**RE: LOT 137 TELLURIDE MOUNTAIN VILLAGE – VESTED PROPERTY RIGHTS MEMO**

**137 GR**  
DRB - FINAL

137  
GRANITE  
RIDGE

# DRB FINAL RESPOSE JUNE 1, 2023 DRB CONDITIONS

**C1.1**

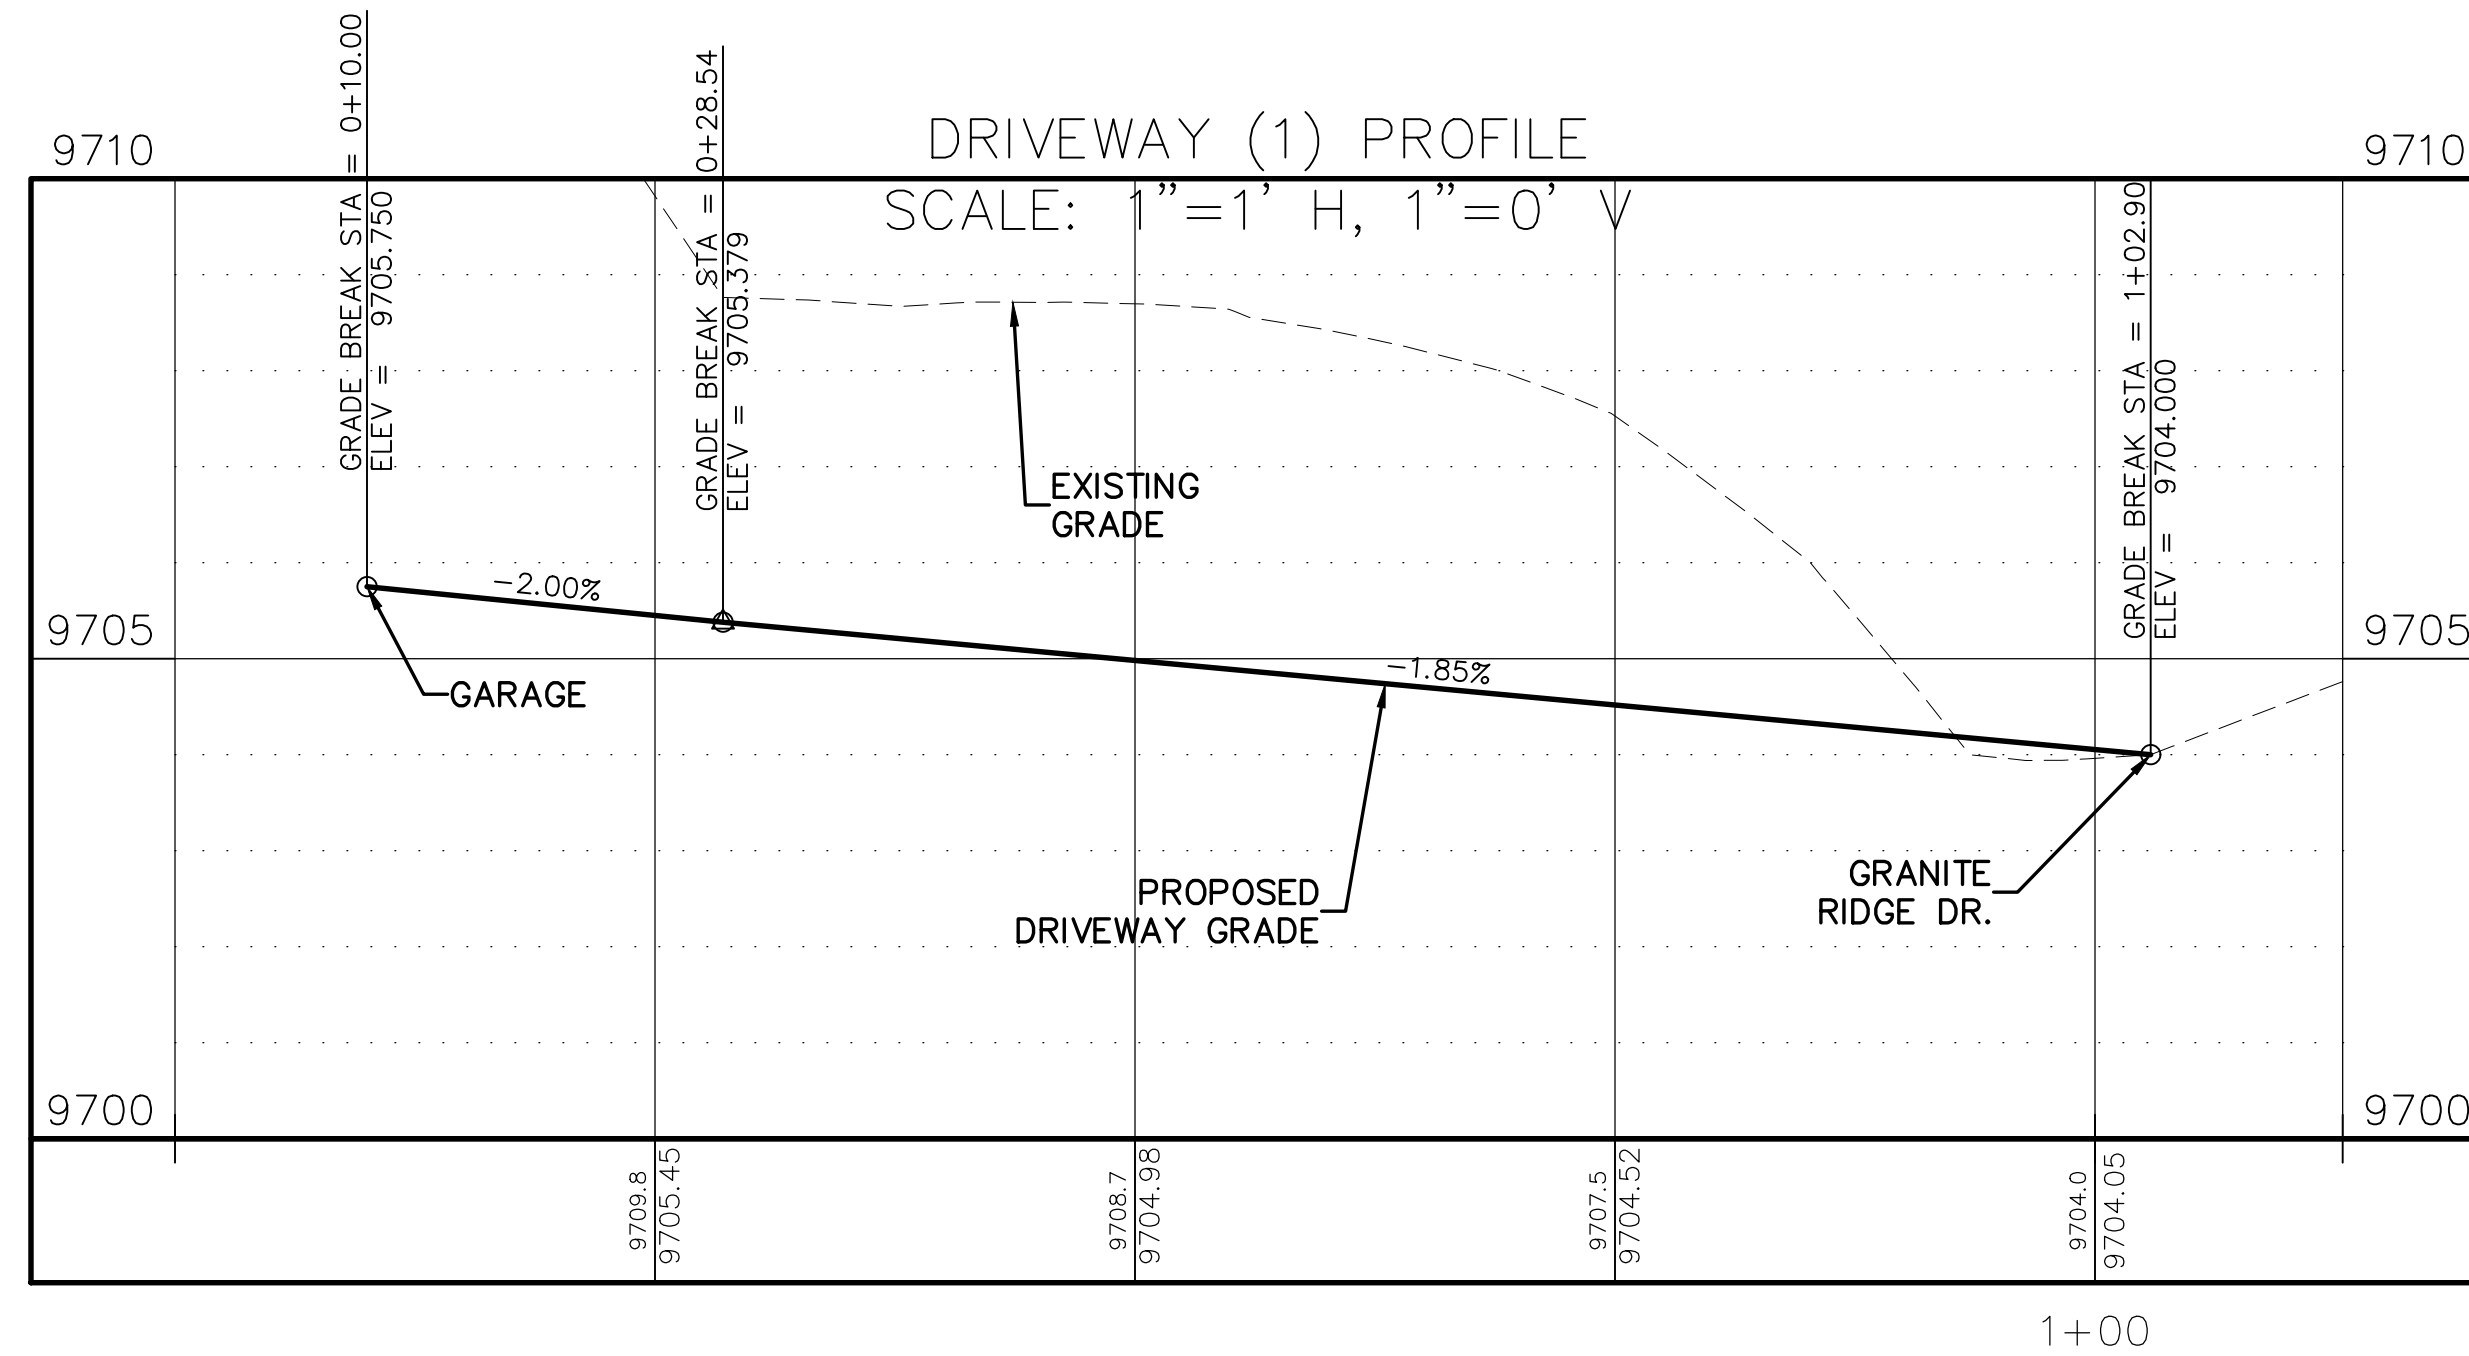
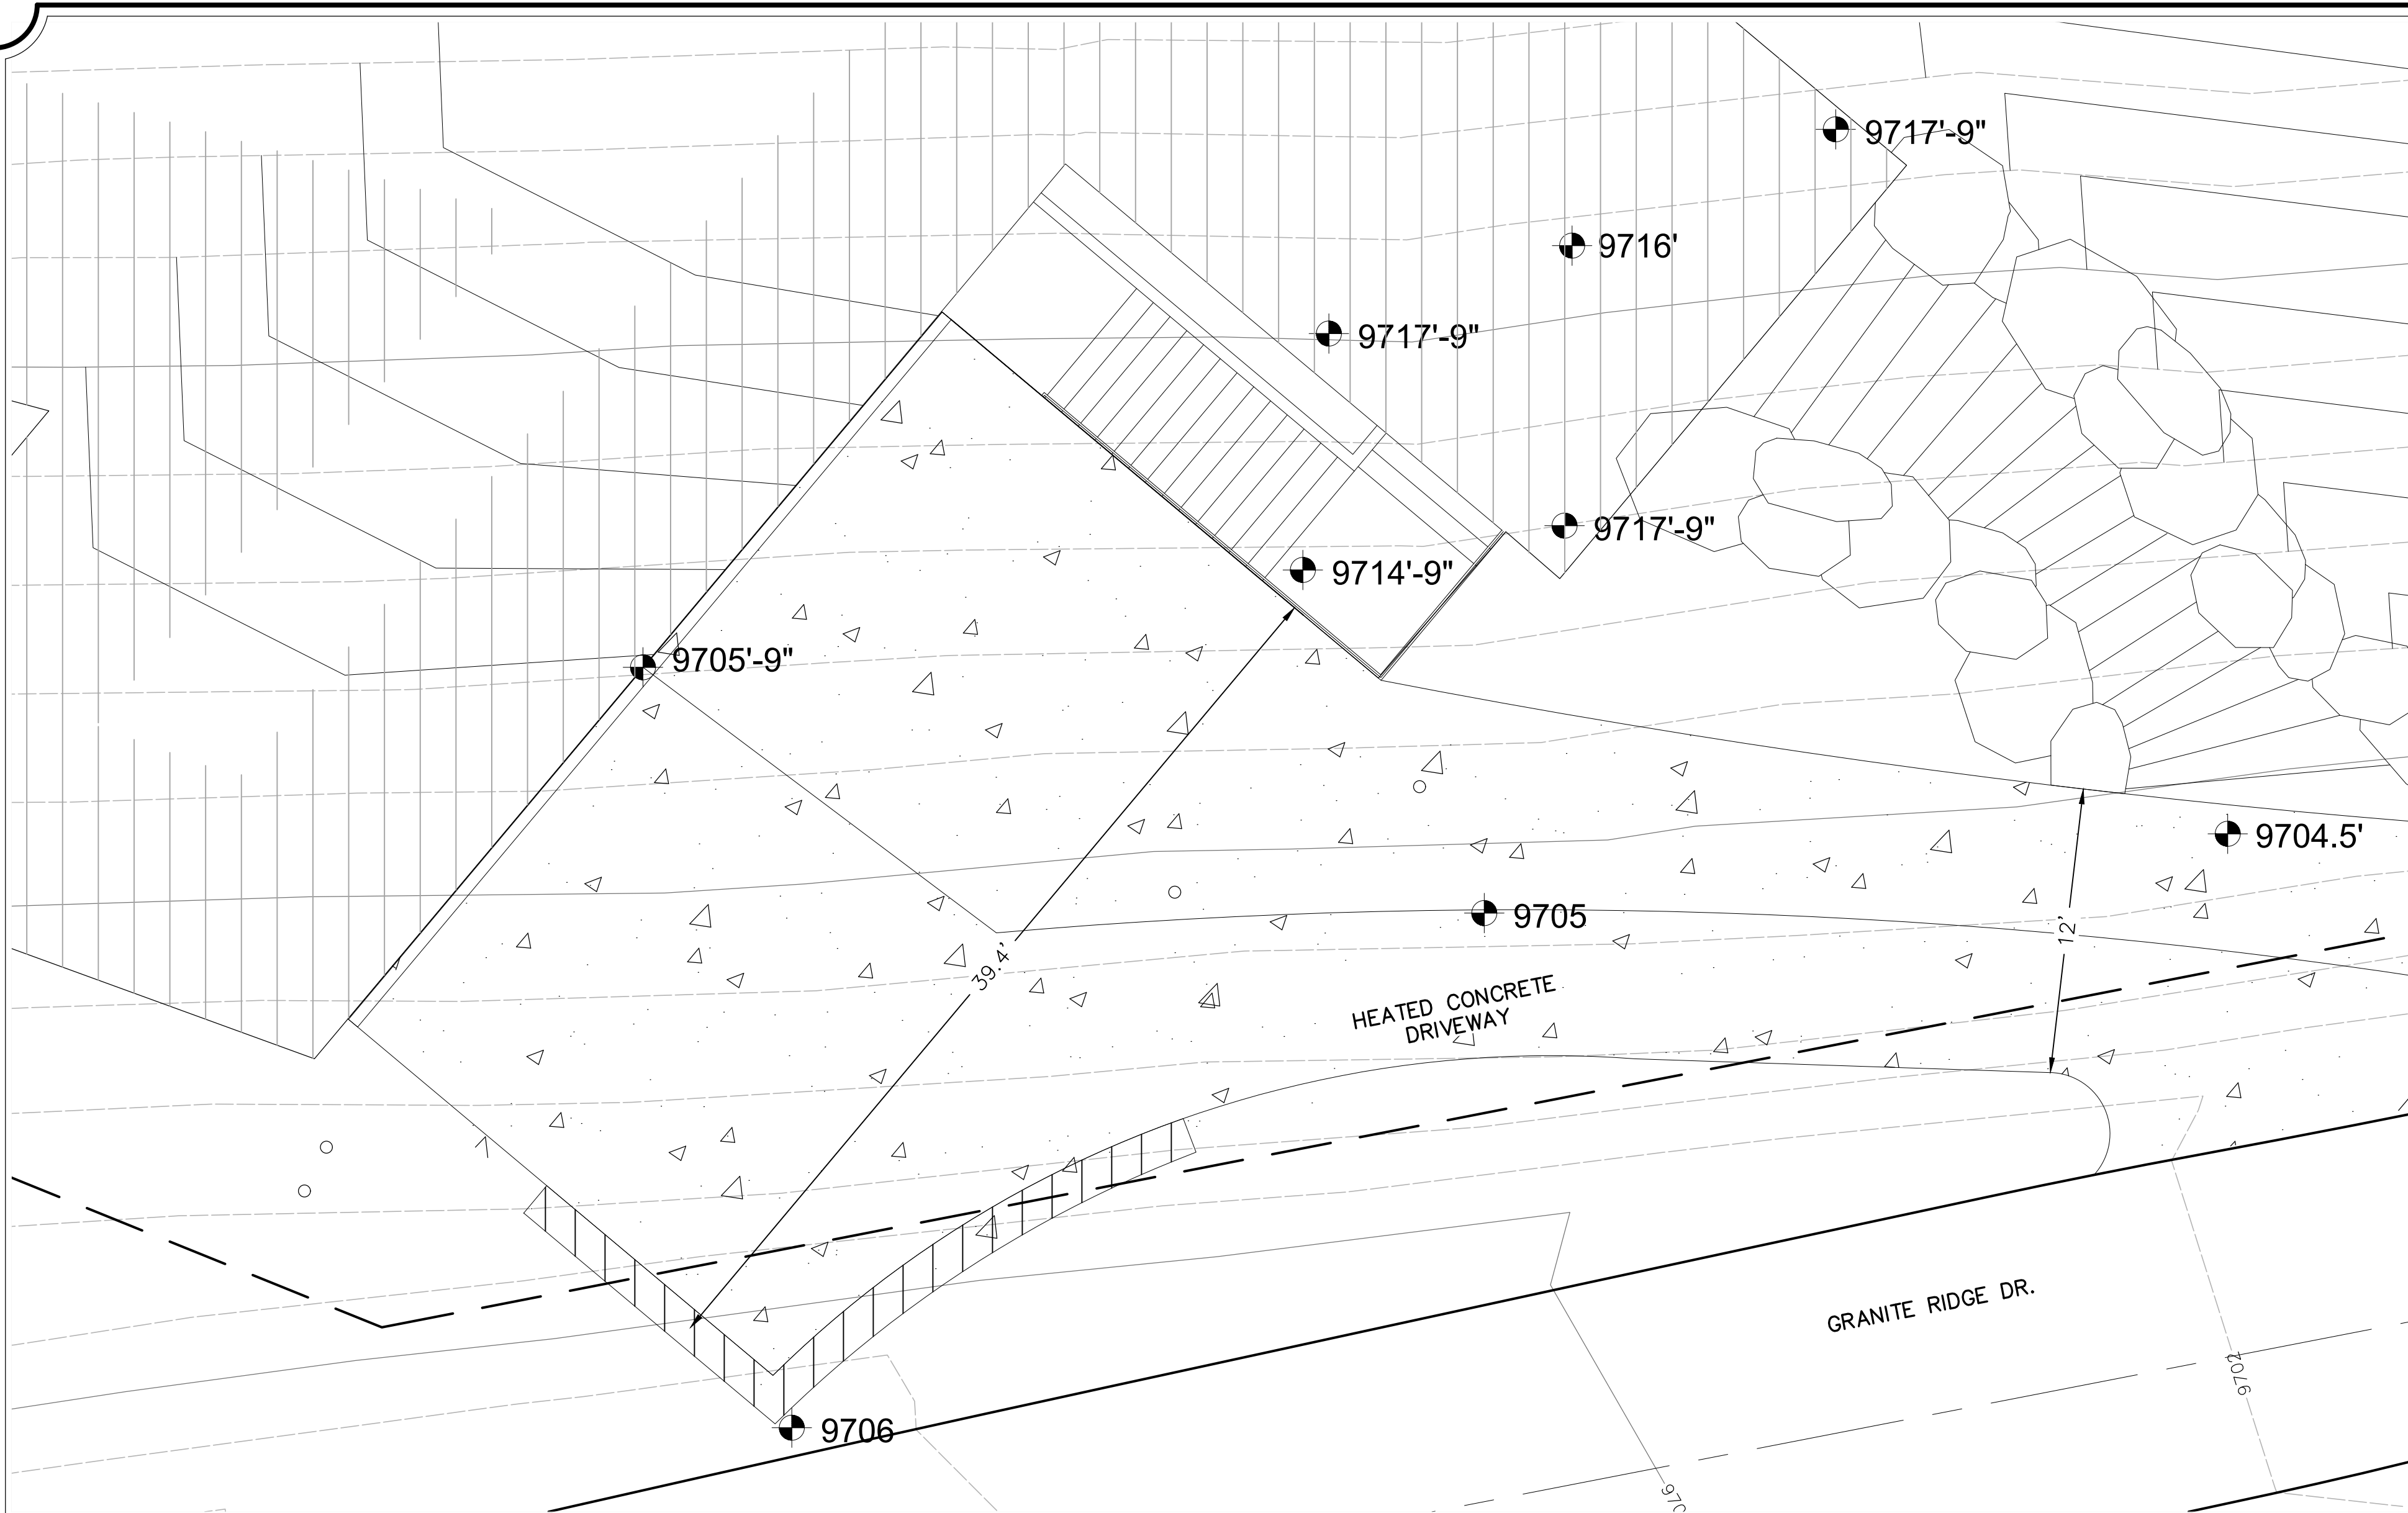
- 1) DRIVEWAY STANDARDS - GRADE

- 4) PRIOR TO FINAL REVIEW, THE APPLICANT SHALL PROVIDE AN EXHIBIT SHOWING THE HEIGHT AND LENGTH OF ALL PROPOSED RETAINING WALLS.
- 5) PRIOR TO FINAL REVIEW, THE APPLICANT SHALL PROVIDE AN UPDATED DRIVEWAY PLAN WITH DIMENSIONS LABELED TO SHOW COMPLIANCE WITH THE CDC.

SEE SHEET C1.1

SEE SHEET C1.1

1 LANDSCAPE | FIRE MITIGATION PLAN  
 SCALE: 3/32" = 1'-0"

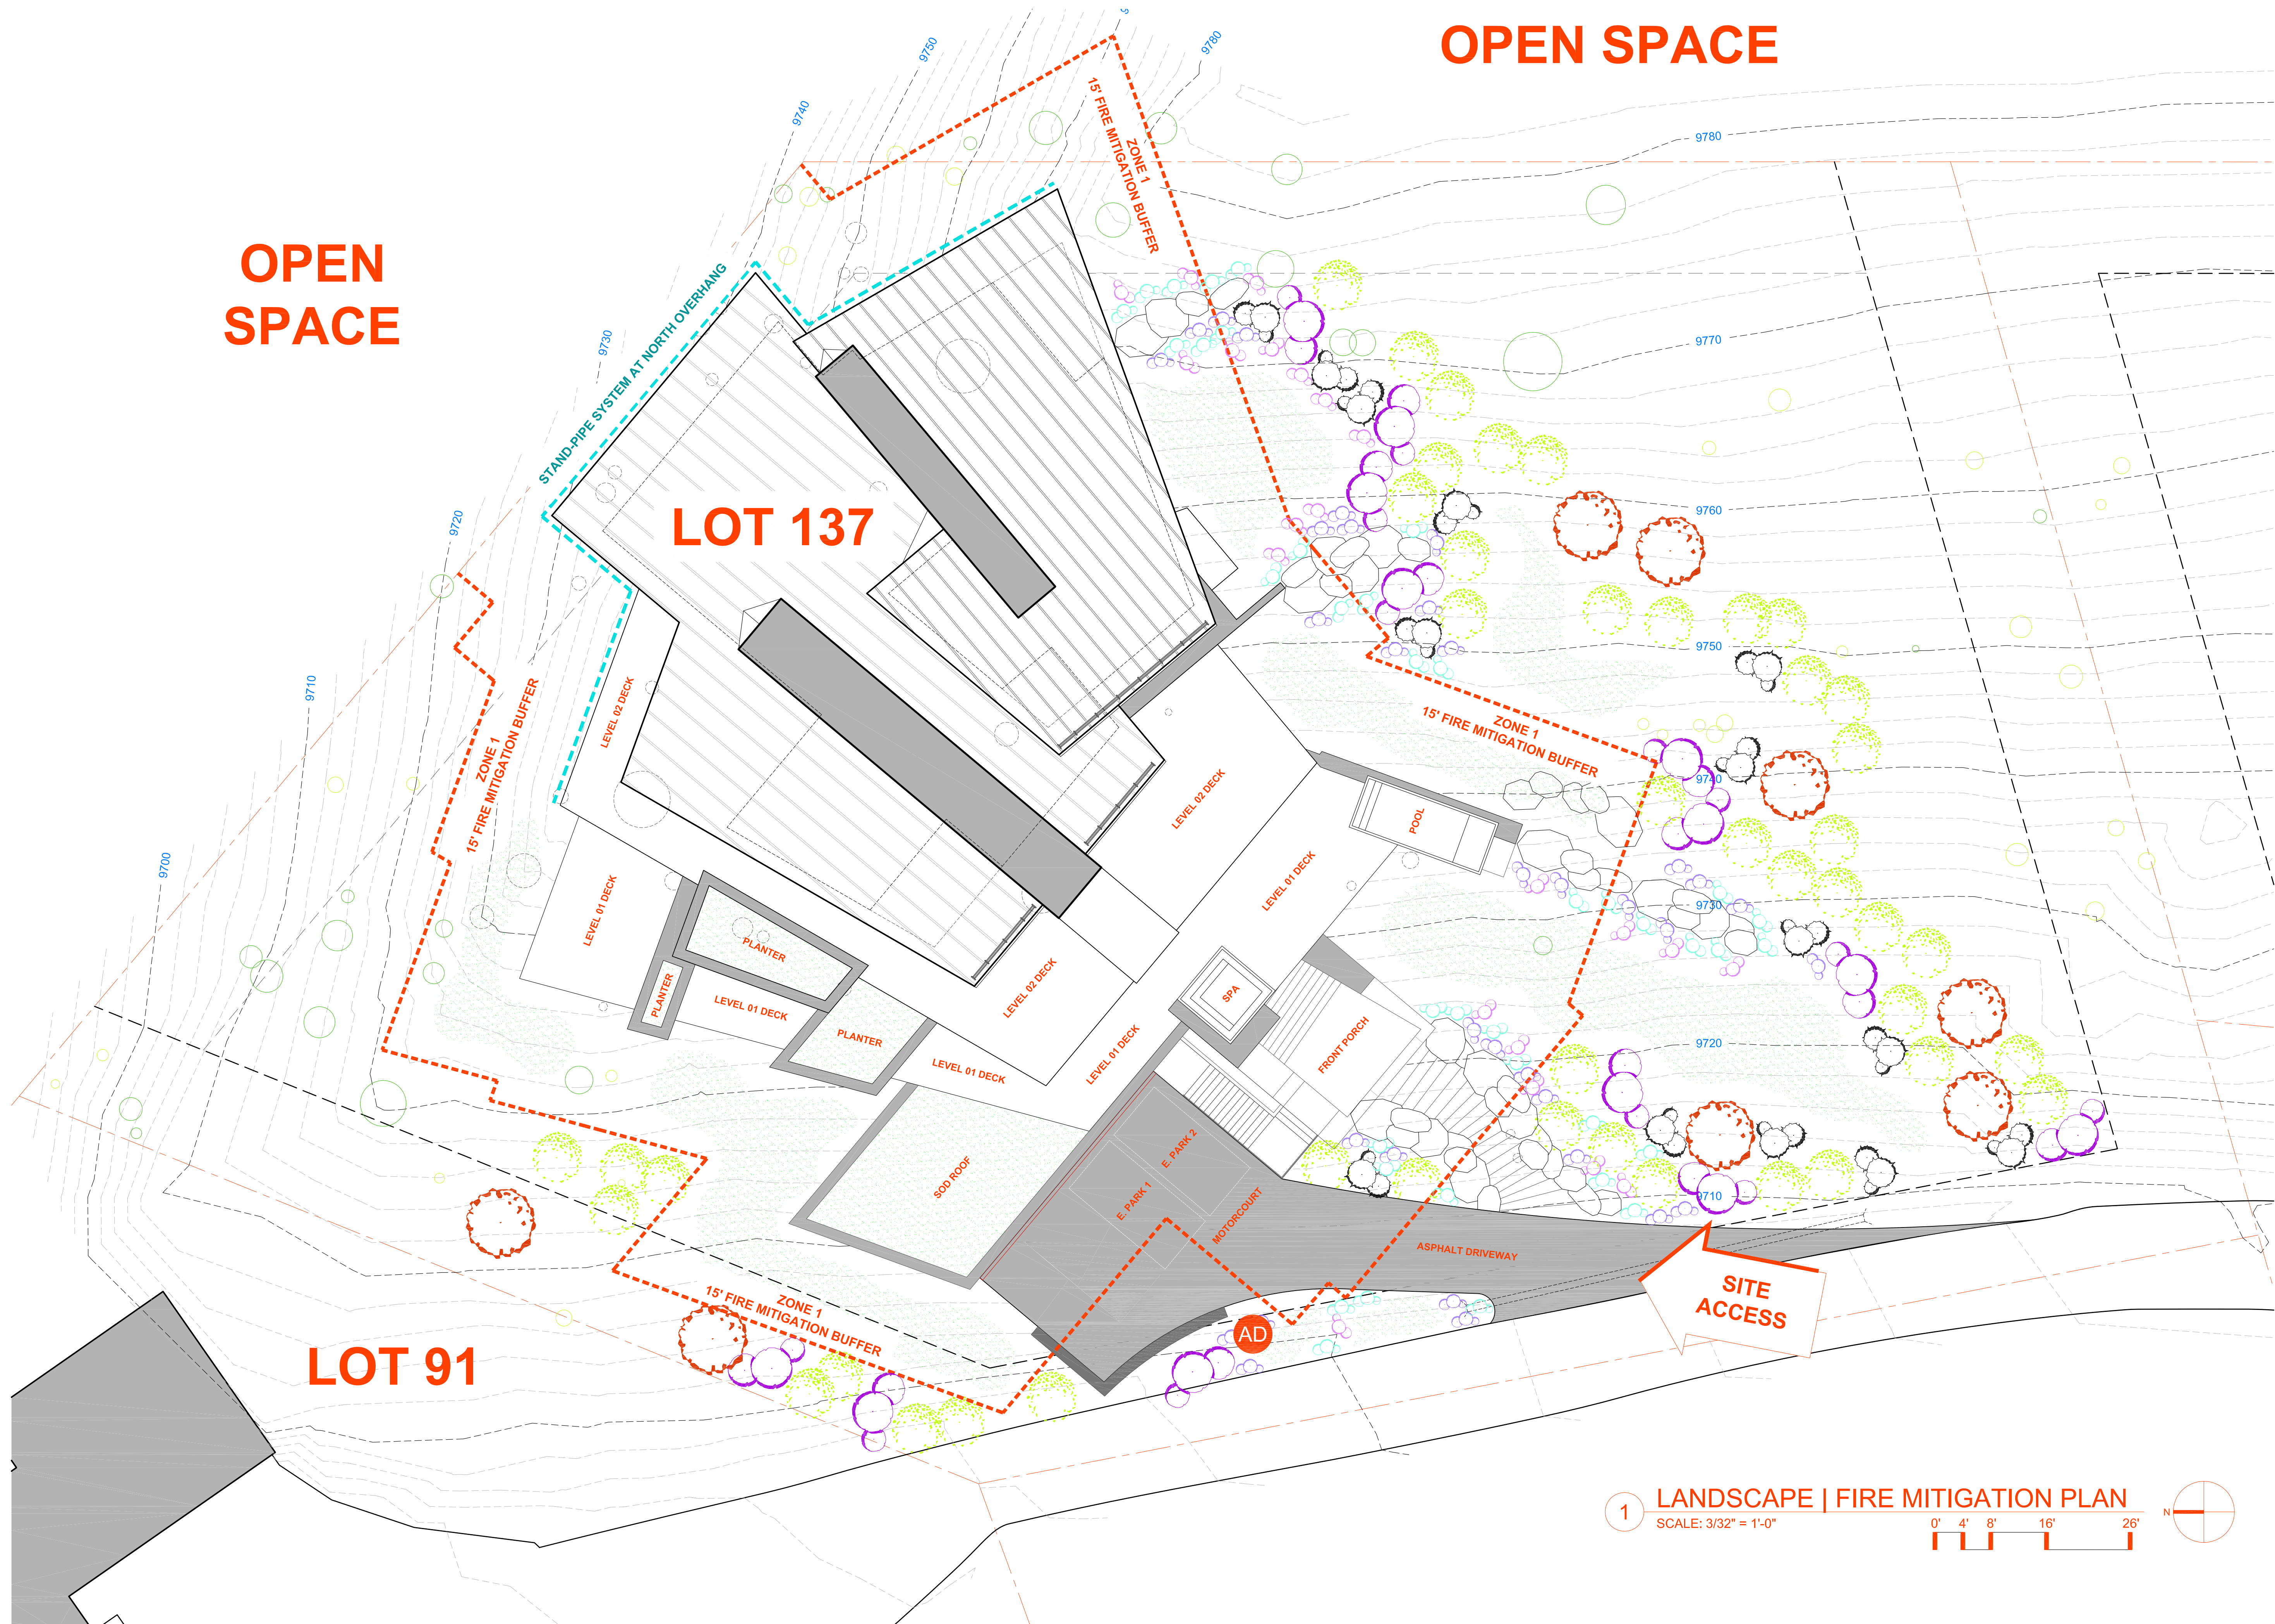
THE LANDSCAPE PLAN SHOWS THE PROPOSED EVERGREEN TREES BEING PLANTED TOO CLOSE TOGETHER. IN ORDER TO MEET THE REQUIREMENTS OF THE COMMUNITY DEVELOPMENT CODE (CDC 17.6), ZONE 2 DEFENSIVE SPACE REQUIREMENTS, THE EVERGREEN TREES MUST BE PLANTED AT LEAST 20 FEET APART AND THEY MUST BE PLANTED AT A DISTANCE TO OTHER TREES AND SHRUBS, SO THEY HAVE A 10 FOOT CROWN SPACING AWAY FROM THESE OTHER PLANTS AT MATURITY. ALSO, TO MEET THE REQUIREMENTS OF THE CDC 17.5.9 LANDSCAPING REGULATION FOR SPECIES DIVERSITY, THE PROPOSED TREES WILL NEED TO INCLUDE A GREATER VARIETY OF SPECIES. THIS MAY BE ACCOMPLISHED BY REPLACING THE PROPOSED EVERGREEN TREES WITH SPECIES ON THE COLORADO STATE EXTENSION PUBLICATION, FIREWISE PLANT MATERIALS AND/OR ADDING A GREATER VARIETY OF EVERGREEN SPECIES TO THE LANDSCAPING PLAN (SO LONG AS THEY ARE SPACED FAR ENOUGH APART TO MEET THE DEFENSIVE SPACE ZONE 2 REQUIREMENTS).

- 3) PRIOR TO FINAL REVIEW, THE APPLICANT SHALL UPDATE THE LANDSCAPE PLAN TO ADDRESS FIRE MITIGATION CONCERNS, ENSURE THAT THE DIVERSITY OF SPECIES REQUIREMENT IS MET, AND PROVIDE INFORMATION ON REVEGETATION AND WATERING.

- 9) PRIOR TO FINAL REVIEW, THE APPLICANT SHALL INDICATE DRAINAGE IN THE GRADING PLAN.
- 10) PRIOR TO FINAL REVIEW, THE APPLICANT SHALL PROVIDE AN UPDATED LANDSCAPE AND FIRE MITIGATION PLANS SHOWING COMPLIANCE WITH THE FIRE MITIGATION STANDARDS.

A STAND-PIPE SYSTEM IS PROPOSED FOR THE NORTH AND NORTHEAST PORTION OF THE OVERHANGING BUILDING ELEMENTS TO PROVIDE THE FIRE MITIGATION WHERE THE SITE TOPOGRAPHY PROVES CHALLENGING.

THIS PROJECT WILL WORK WITH TELSKI TO GAIN PERMISSION TO PERFORM ZONE 2 DEFENSIVE SPACE FUEL REDUCTIONS AND MODIFICATIONS TO THE FOREST TO A DISTANCE OF 150 FEET FROM THE HOME ALONG THE NORTHEAST PROPERTY BOUNDARY.  
 THE DESIGN OF THE HOME HAS MANY OVERHANGS AND THE DESIGN OF THE HOME'S OVERHANGS, DECKS AND SOFFITS IS COMPOSED OF NON-FLAMMABLE MATERIAL. THE DECKS (ESPECIALLY THE UNDERSIDES) ARE CONSTRUCTED FROM FIRE RESISTANT | NON-COMBUSTIBLE MATERIAL AND THE ROOF IS ALSO CONSTRUCTED FROM A NON-COMBUSTIBLE MATERIAL.
